Service letter NO. 2
Model effected Bee Dee M-4 & M-4
Serial number effected 3-55

Installation of Balance Weight

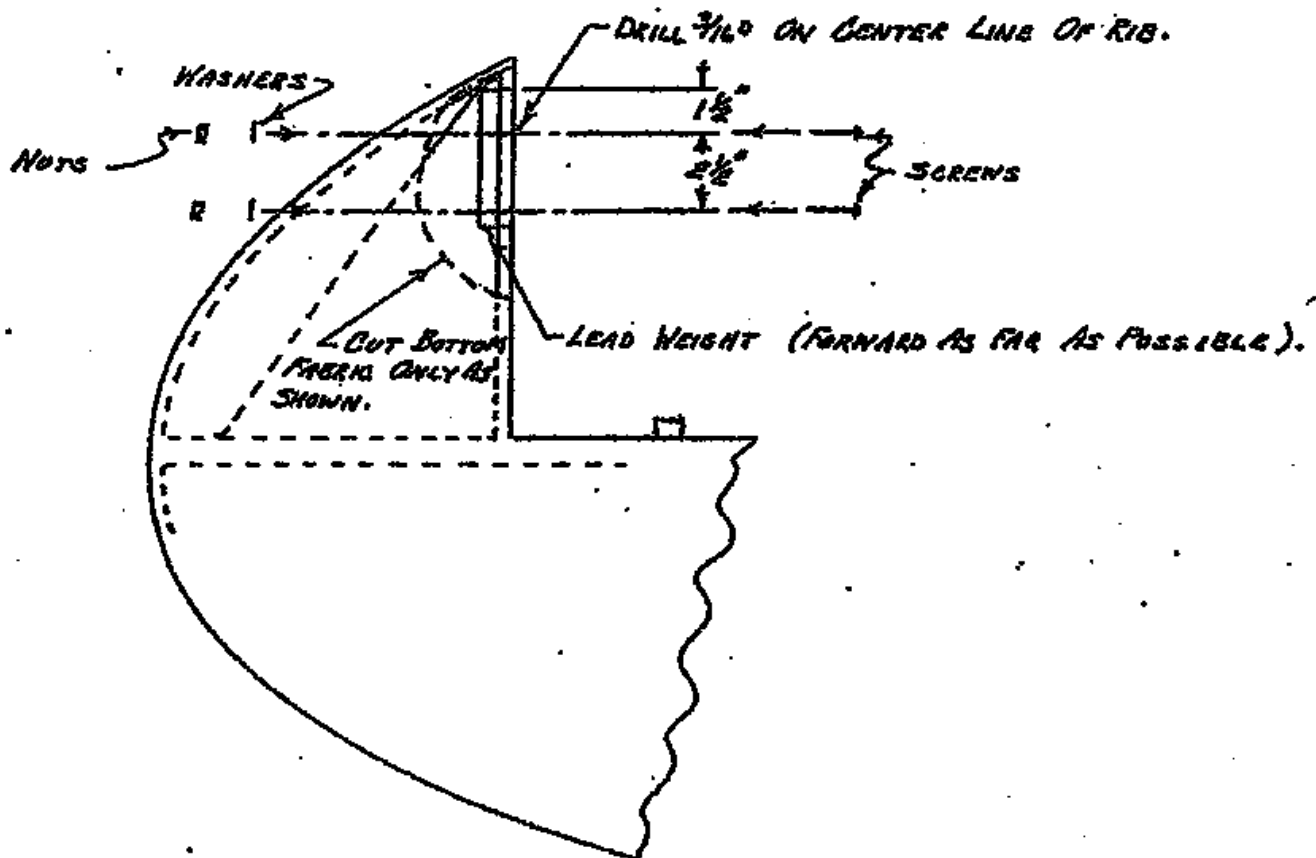
It will be required to add a balance weight to the elevator of your aircraft. I am forwarding with this letter the required weight, attaching hardware and installation drawing.

1. Lead Weights (2 req'd) (per dwg CD-A560).
2. Screws AN526-10-R24 (4 req'd)
3. Nuts AN365-1032 (4 req'd)
4. Washers AN960-10 (4 req'd)
5. Fabric covering and dope. (use butyrate dope).

1. Remove fabric from bottom of elevator as shown on drawing.
2. Install lead weight as far forward as possible and clamp it to the rib for drilling.
3. Drill the two $3/16$ holes at the locations noted on the drawing.
4. Install the screws, washers and nuts as noted.
5. Recover cut out area as per CAMLS.
